TECHNICAL INFORMATION

RECALL Idler Pulley Replacement

No: D216
Ref:
Issue: 3
Date: 12/08/00

Figure 4

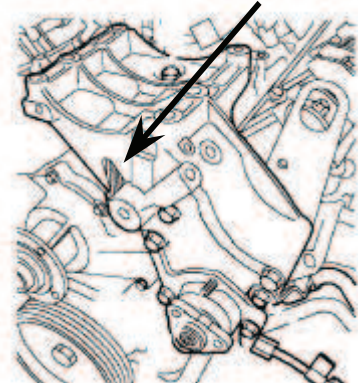
CAUTION: Casting flash on the idler mounting base can cause dimensional variances which may result in interference with the new steel idler pulley. Inspection and verification of proper clearance must be made to ensure correct installation.

6. Rotate pulley and verify proper clearance of 0.5mm (0.020 inches) from engine mounting bracket casting.
7. Relieve excess casting material if required. (Figure 4)
8. Inspect the belt for damage before installation.
9. Install the belt following the WSM procedure and tighten the tension pulley to **45Nm (33 lbf.ft.)**.
10. Refer to WSM section 26.25.19 and install the cooling fan assembly.
11. Install the drive belt cover.
